HISTORIC PRESERVATION BOARD STAFF REPORT

202 N. Swinton Avenue

Meeting	File No.	Application Type
October 16, 2024	2024-192	Certificate of Appropriateness, Level 1 Site Plan Modification, Demolition, and Variance

A6 FINAL REVISIONS ENTRY (EAST) ELEVATION: MAIN STRUCTURE

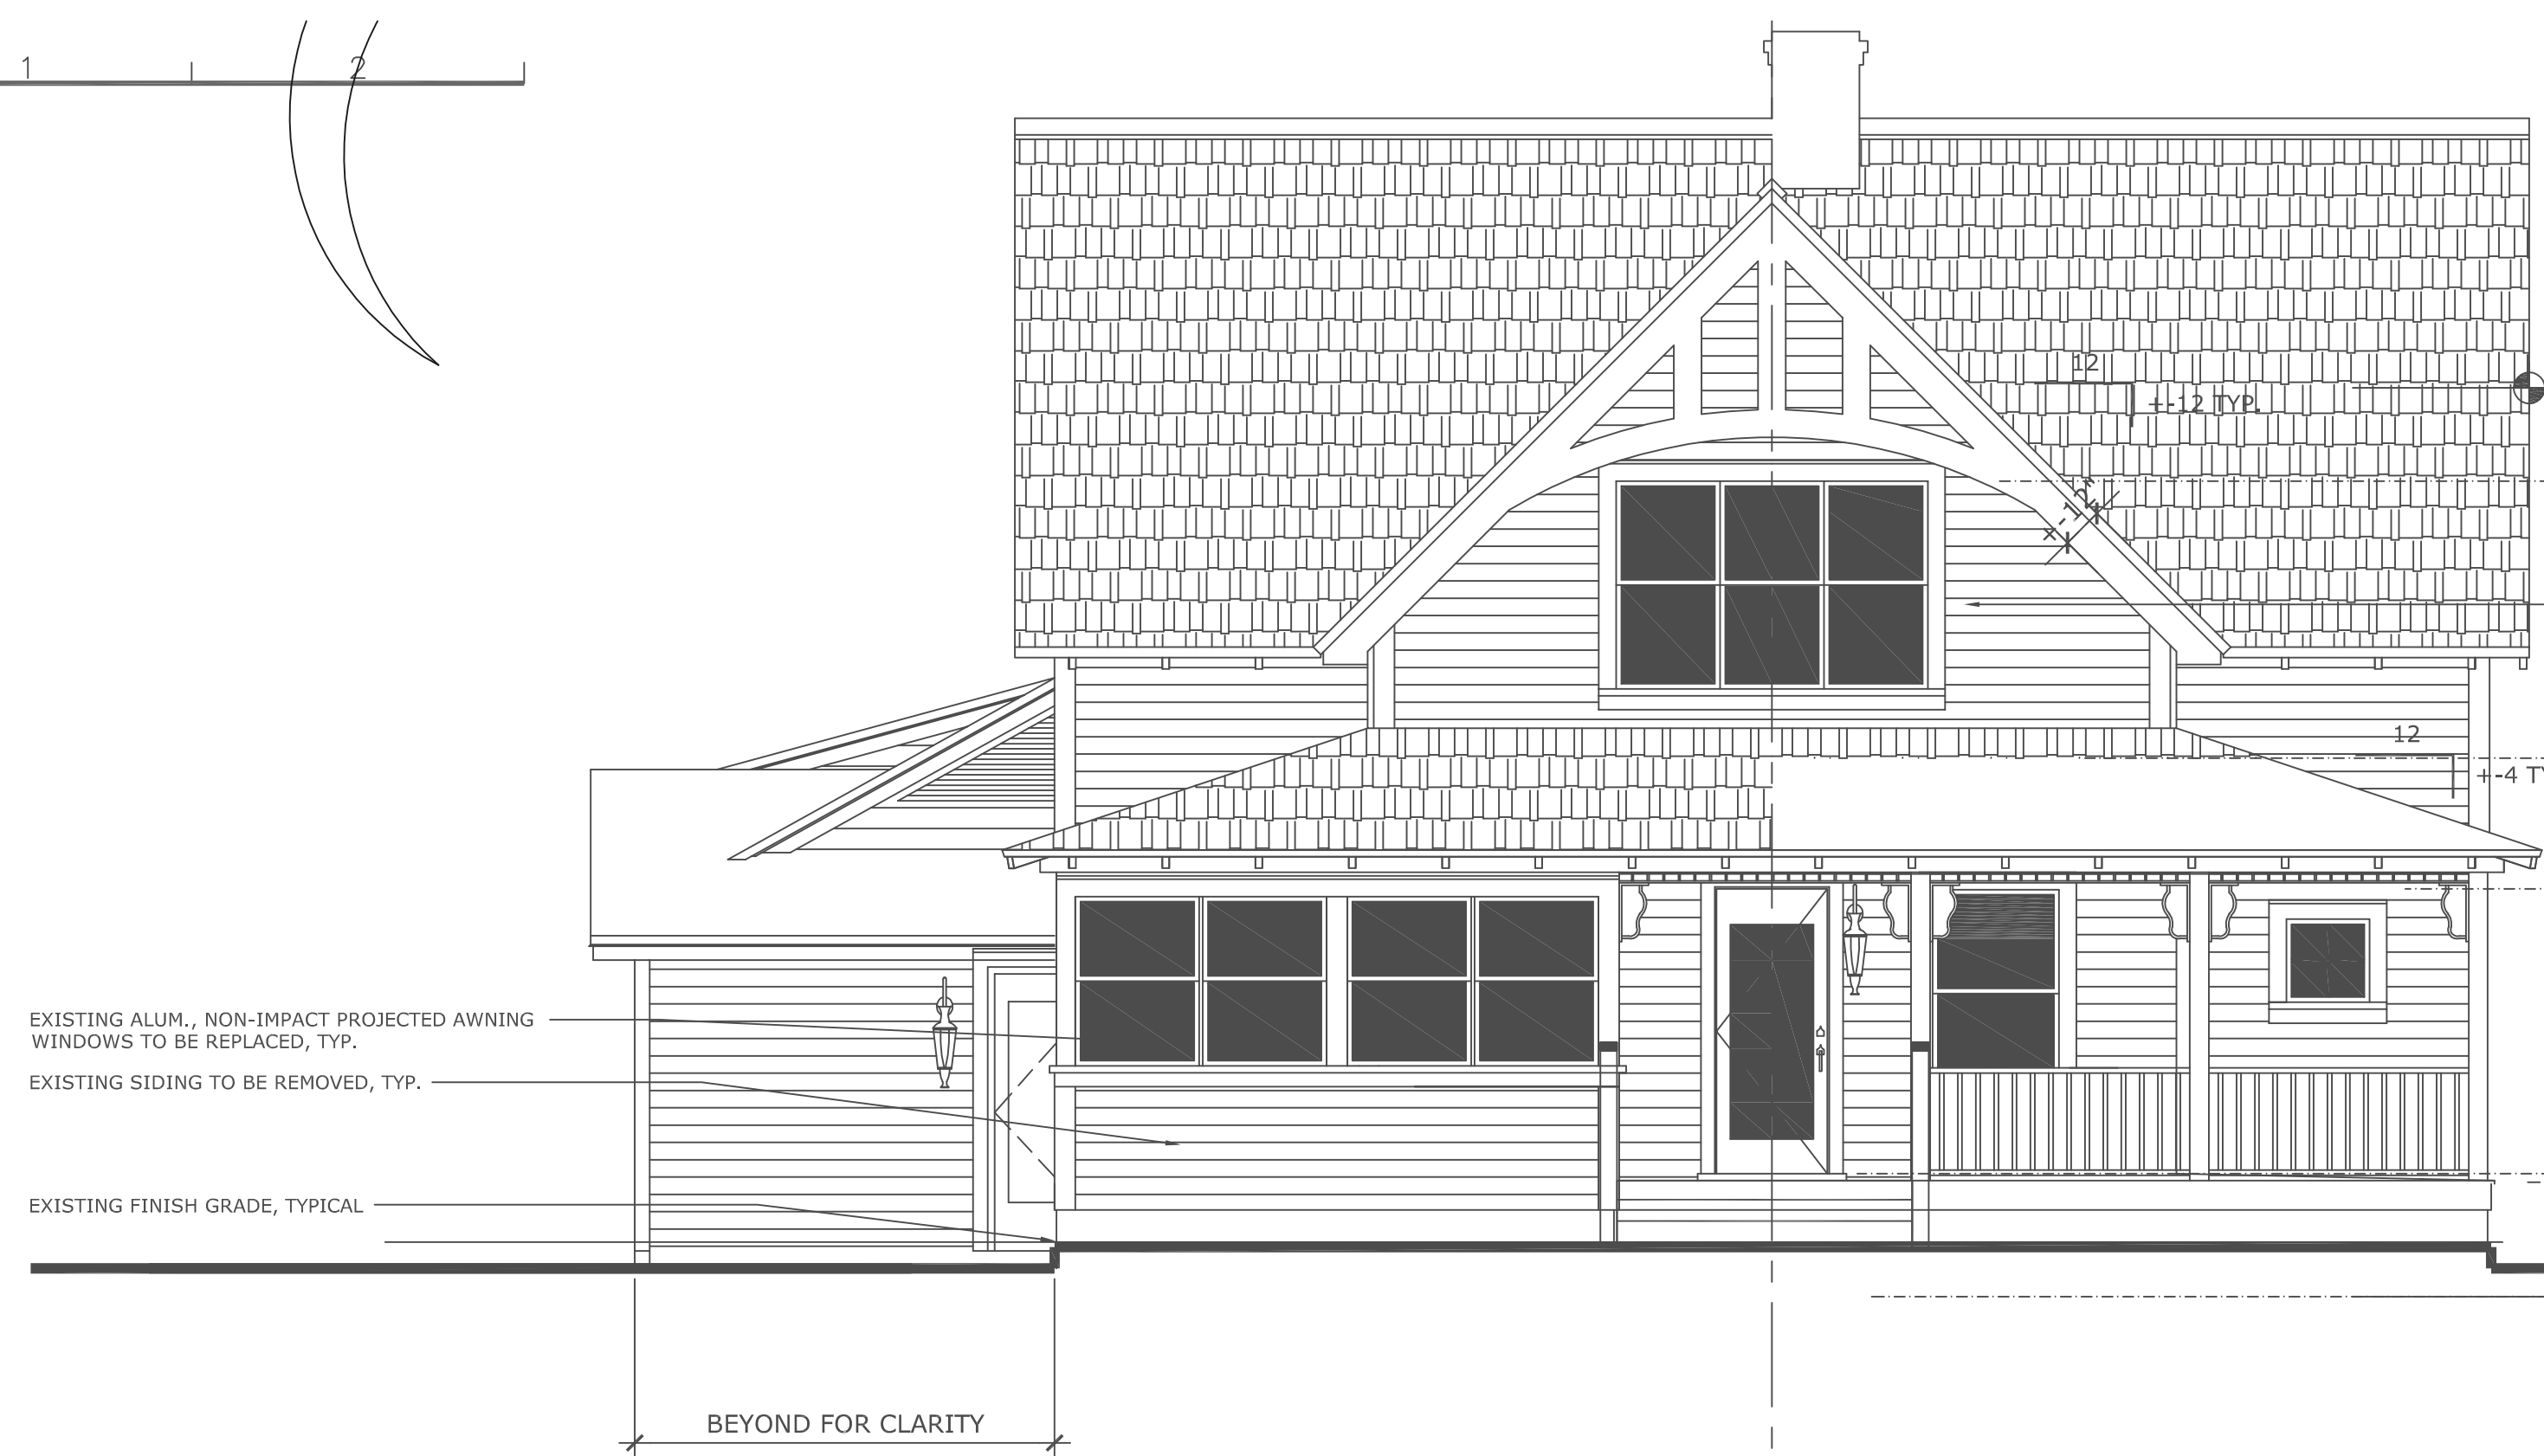
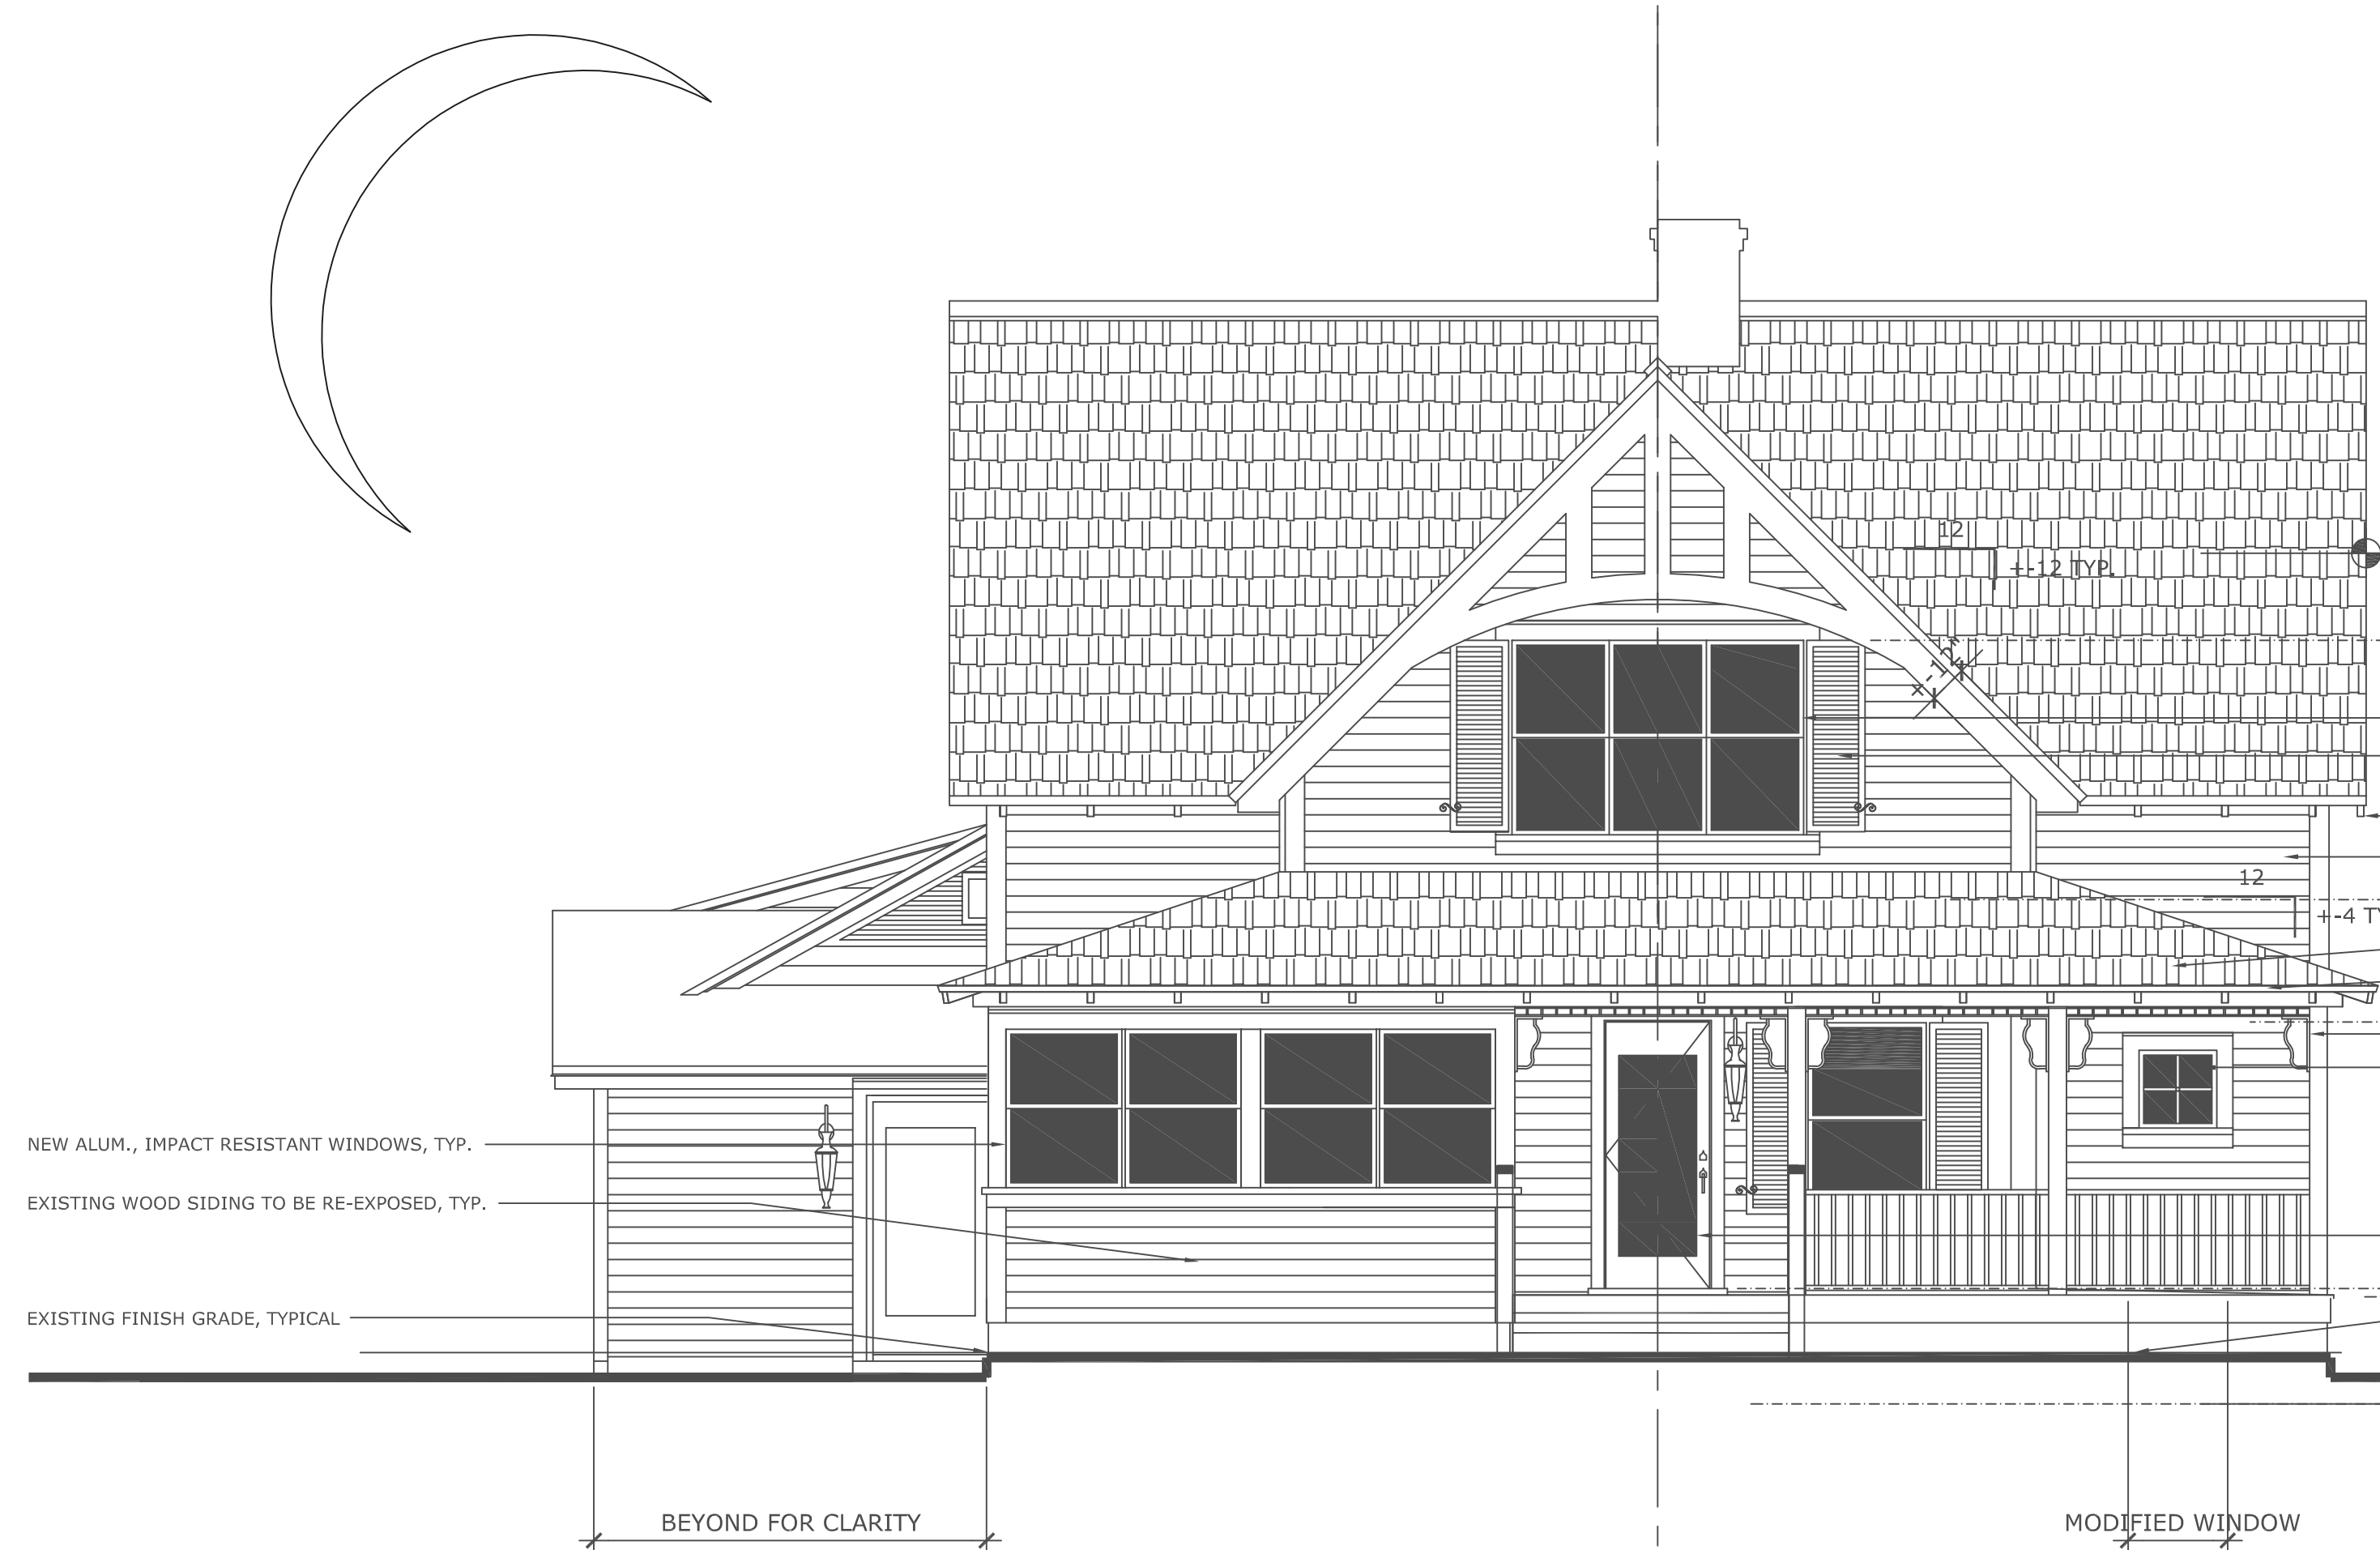
All approved and existing shutters are no longer requested on either structure, and the existing ramp pavers are also proposed to be replaced/repared in place. These elements can be considered appropriate and compatible for both the main and the accessory structure, while being harmonious between the two. Consideration could be given to eliminating the roof design feature above the entry door on the south elevation since the transom window is proposed to be eliminated. This is due to the fact that the “pop-up” of the roof feature no longer serves a utilitarian purpose. Also, the board should consider whether or not it is appropriate to retain the shutters along the east entry (primary façade). It
